**APPLICATION REVIEW FOR
LOW IMPACT HYDROPOWER INSTITUTE CERTIFICATION
of the
GREEN MOUNTAIN POWER
ESSEX 19 HYDROPOWER PROJECT NO. P-2513**

REVIEW OF APPLICATION FOR CERTIFICATION BY THE LOW IMPACT HYDROPOWER INSTITUTE OF THE ESSEX 19 HYDROPOWER PROJECT

Prepared by: Patricia McIlvaine, April 1, 2017

Updated and revised November 6, 2018, Maryalice Fischer

Recommended Temporary Solution: Alternative 2

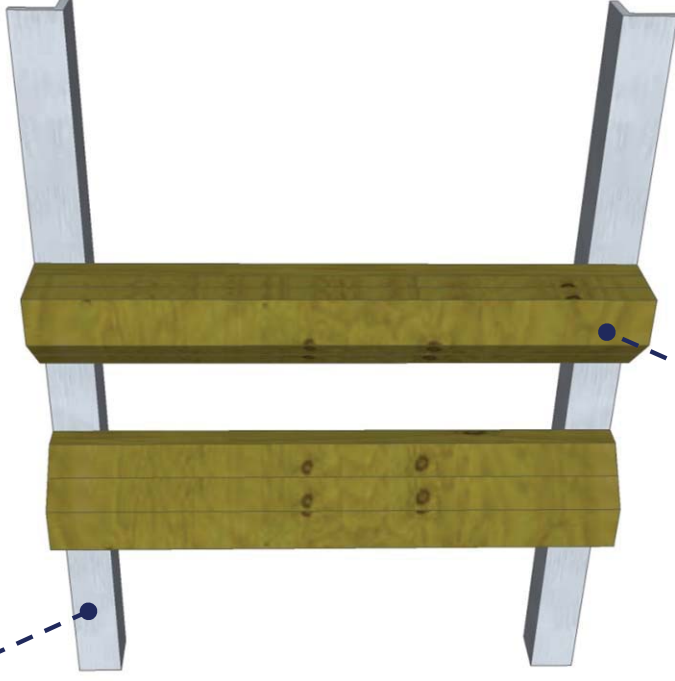
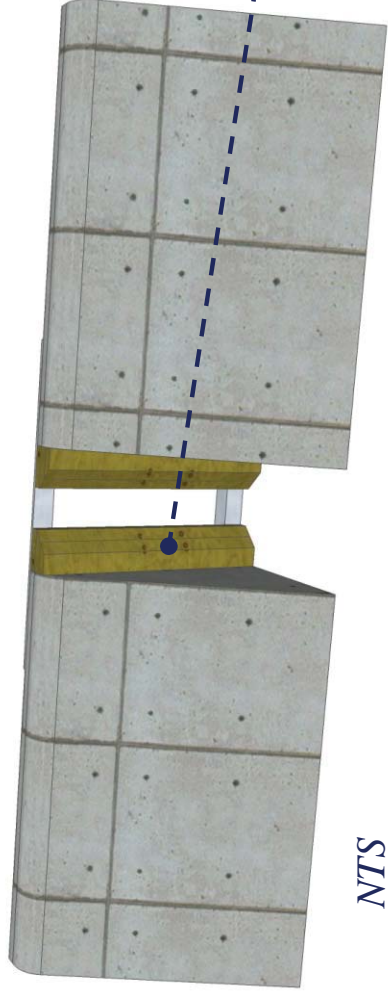
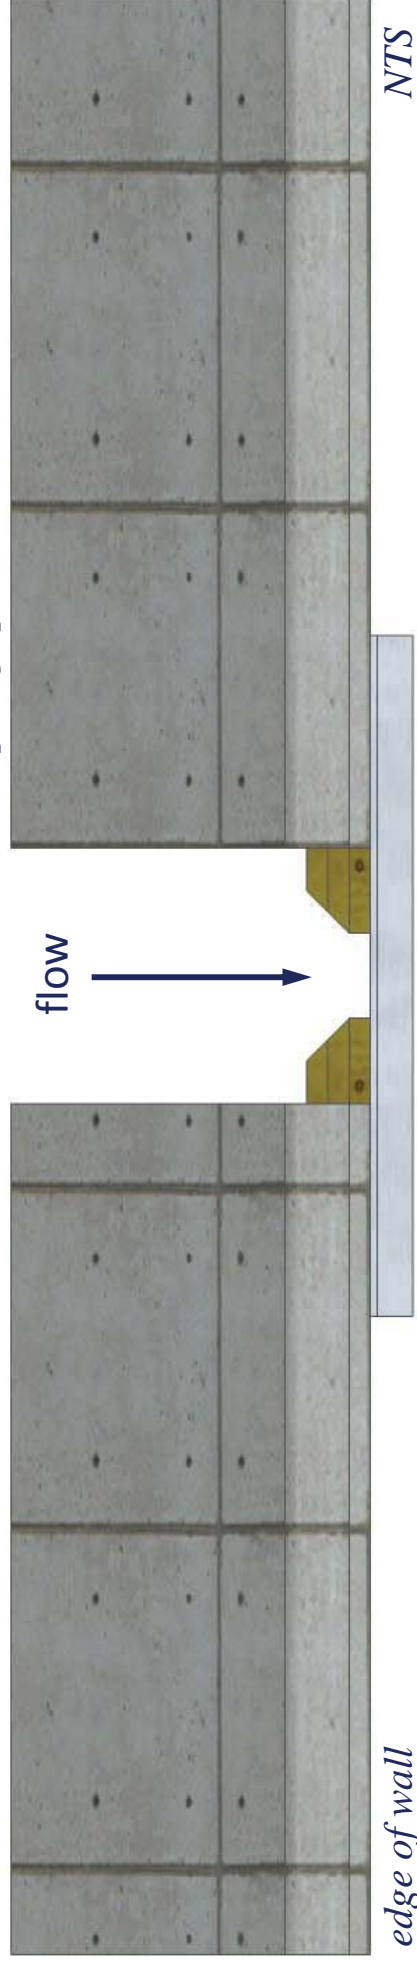
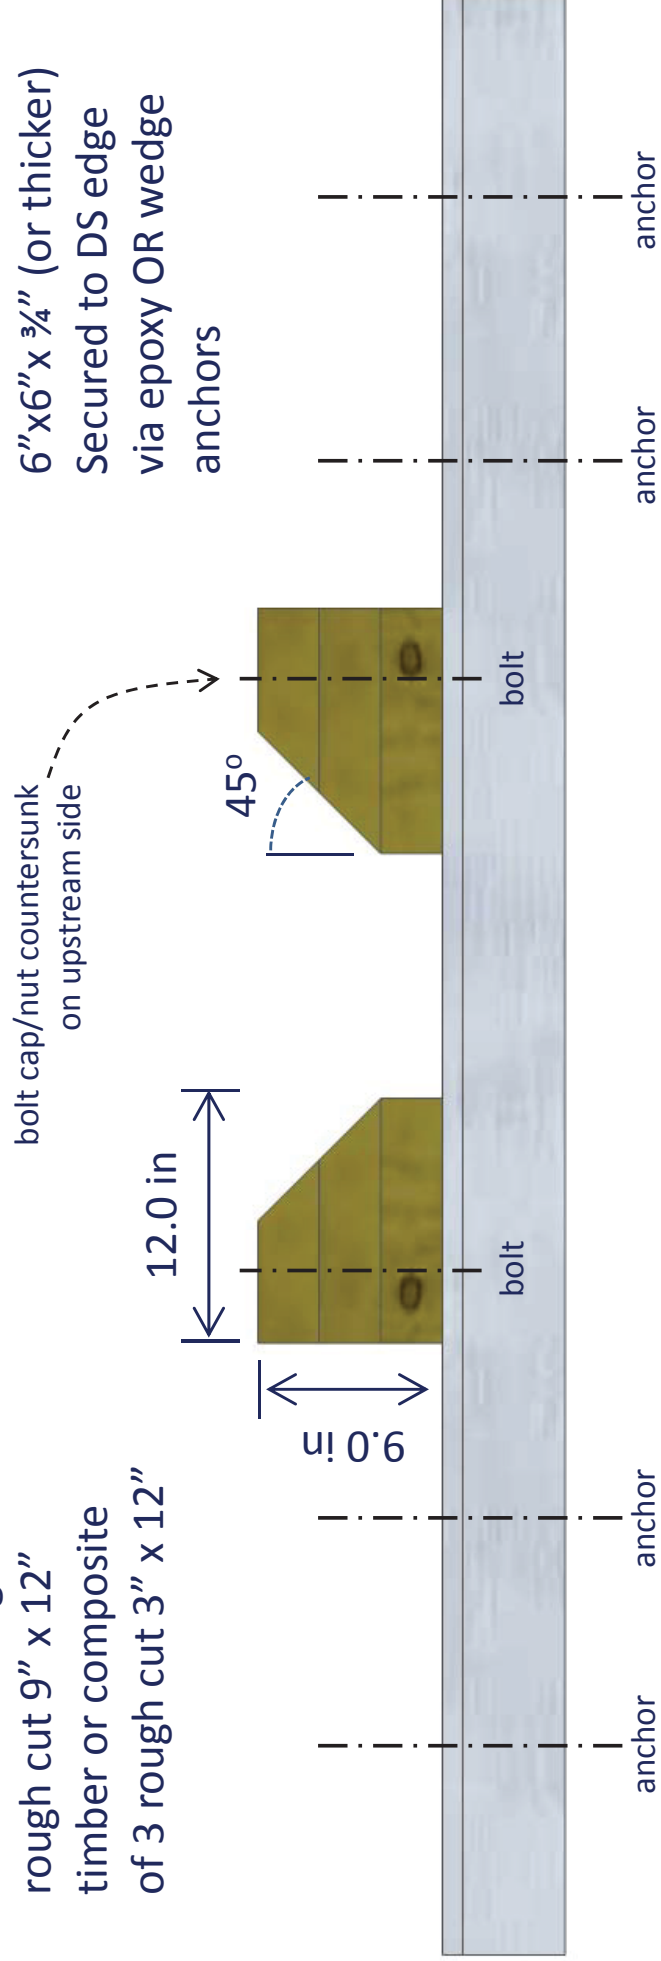
Steel cross-members provide support for timbers in notch

Cross supports may be necessary to support timbers.

Timbers contract cross-section of notch

Achieves a similar effect as bell-mouthed vertical slot steel insert by restricting conveyance

Mitered timbers
Built from a single
rough cut 9" x 12"
timber or composite
of 3 rough cut 3" x 12"

Steel Cross Member
Galvanized A36 steel
6" x 6" x 3/4" (or thicker)
Secured to DS edge
via epoxy OR wedge
anchors

Temporary Solution:
Timber Contracted Slot

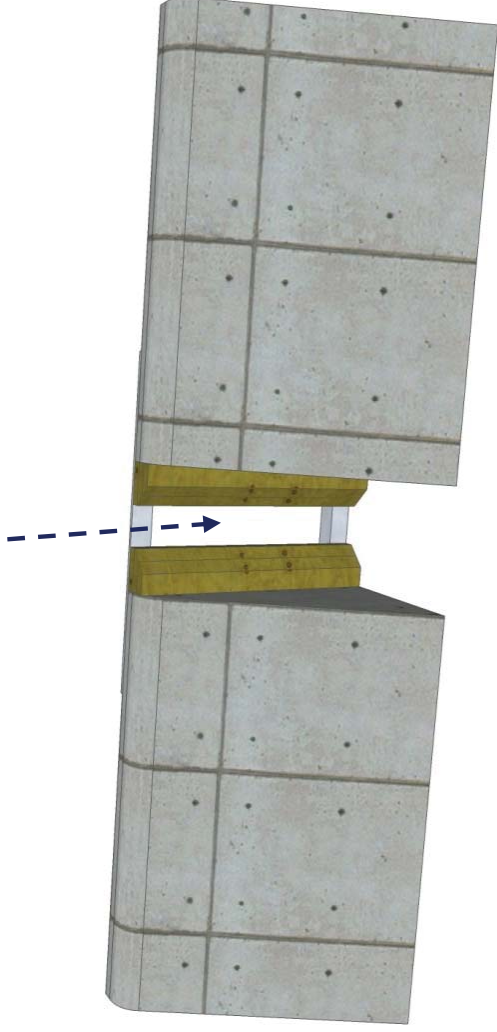
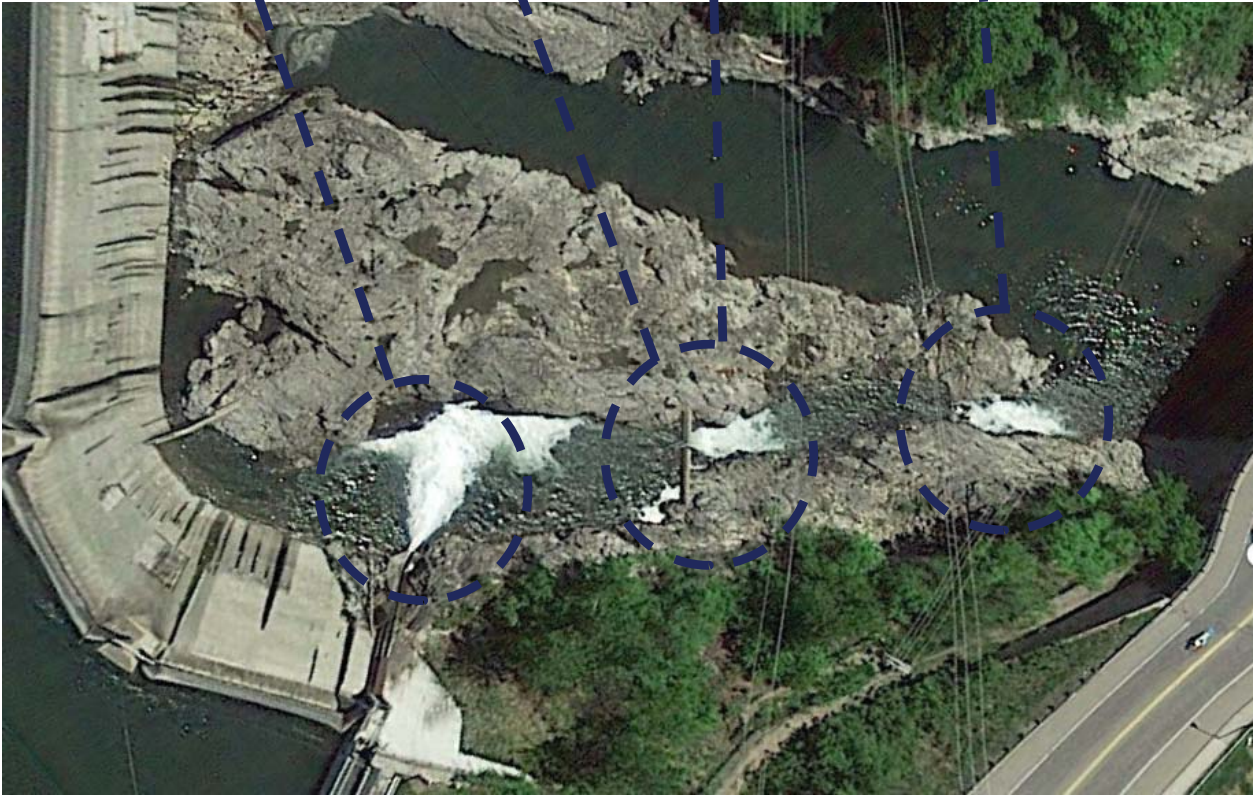
DS weir slot as installed
by GMP, July 2018

weir slot concept recommend by
Service 11/3/17

- 1. Improving hydraulics of DS chute jet as it enters the plunge pool. *Addressed in August 2017.*
- 2. Modify existing weir into a weir slot. *Temporary solution installed in July 2018*
- 3. Ensure transition into lower pool is safe. Jet must fall into 4 ft + of receiving water and nappe must not impact bedrock
- 4. Backwater lower pool with rock to provide at least 4 ft depth of water

Characteristics of Permanent Weir Slot

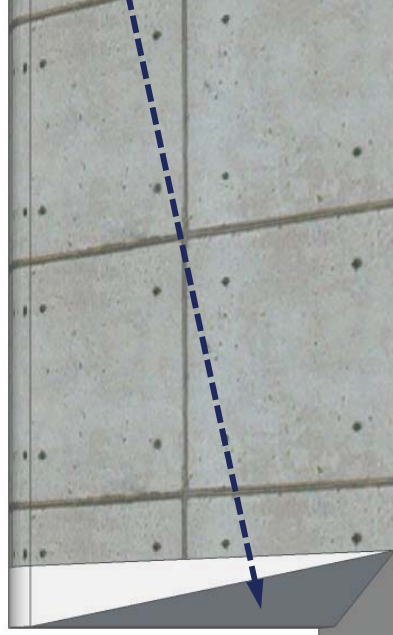
Permanent modifications could be constructed out of concrete. Details:

1. Contraction should be set to 1 ft (sufficient to backwater plunge pool while large enough to promote movement of out-migrating smelts and kelts)
2. Base of slot should be sloped upwards (longitudinally); this will allow lower nappe to spring over some exposed bedrock; however, additional bedrock may need to be removed from lower pool (see page 7)

Slope up ~ 9 inches along base of slot

Gradual slot contraction to prevent flow separation and promote gentle accelerations

Fabricated metal insert;
permanent weir slot w/ramp

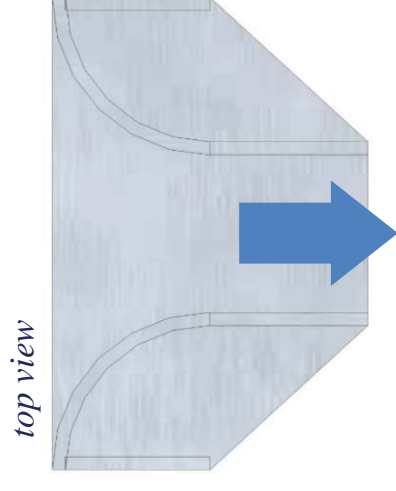
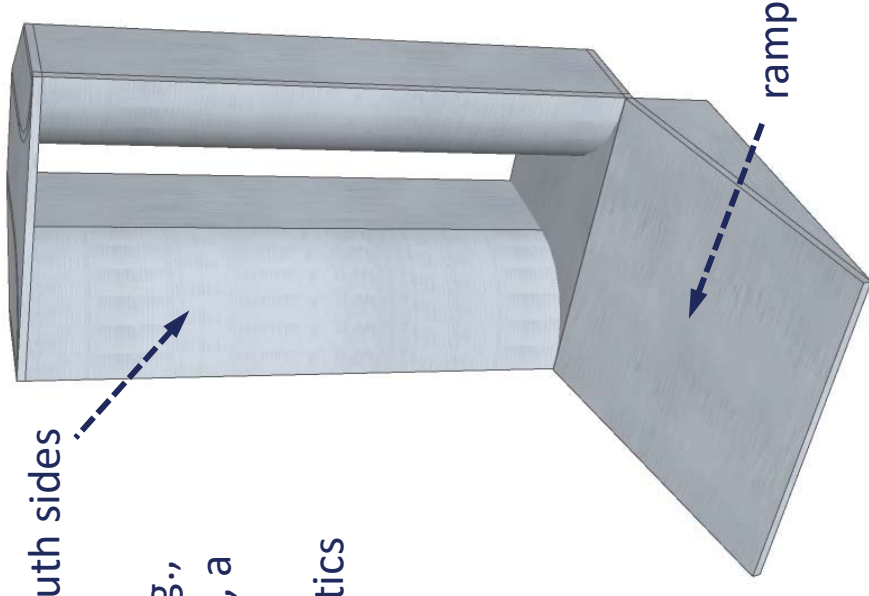
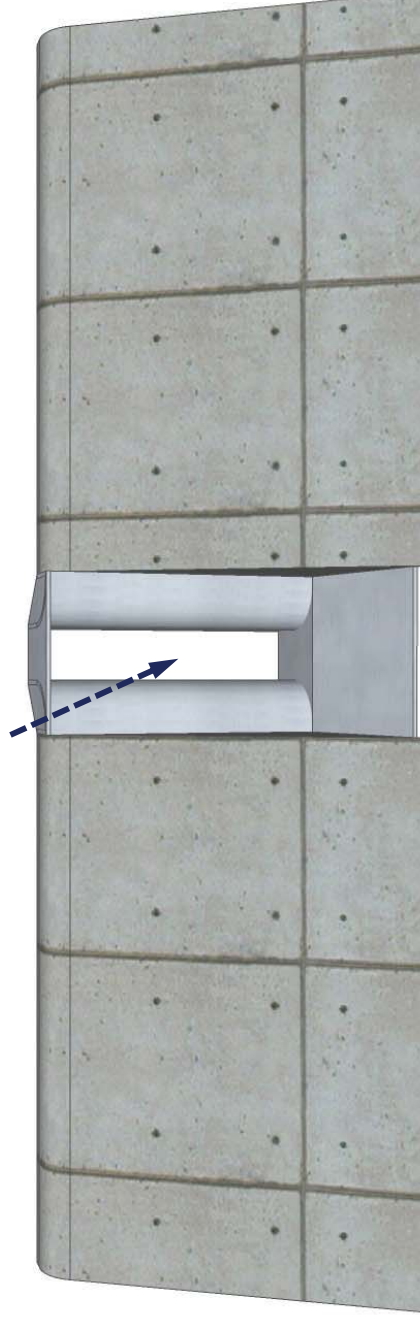
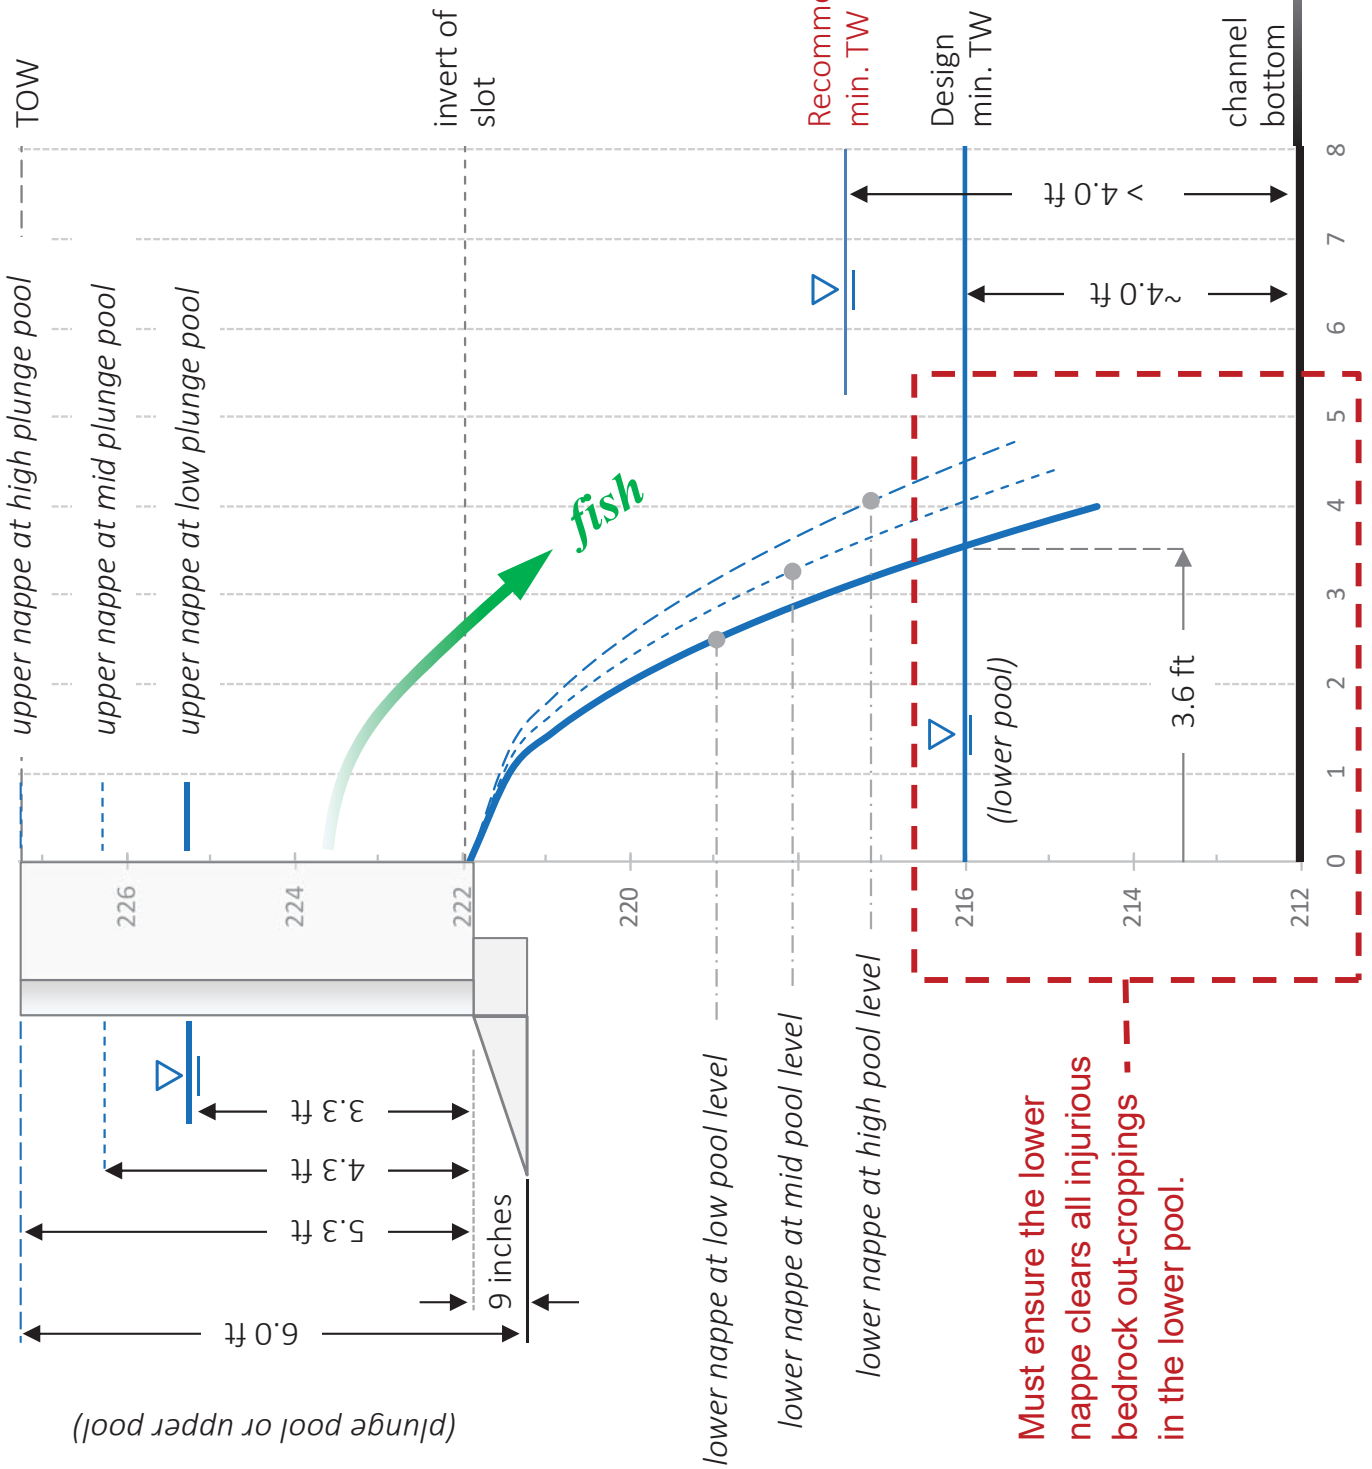
A concrete permanent weir slot may prove difficult to construct (e.g., complicated form work, bonding to existing concrete). Additionally, a concrete weir slot cannot be removed. Alternatively, GMP could consider a fabricated metal insert with the same design characteristics (this is a variant of the insert proposed in 11/3/17 document):

1. 3-ft wide, 6-ft tall insert (SS or alum)
2. Bottom 9-inch ramp to elevate lower nappe; upper 5.25 ft vertical slot
3. Bell-mouthed sides to promote gentle spatial acceleration known to enhance smolt migration

Note: nappe profiles calculated using projectile motion equations with initial velocities estimated from orifice equation (C=0.75 for vertical slot)
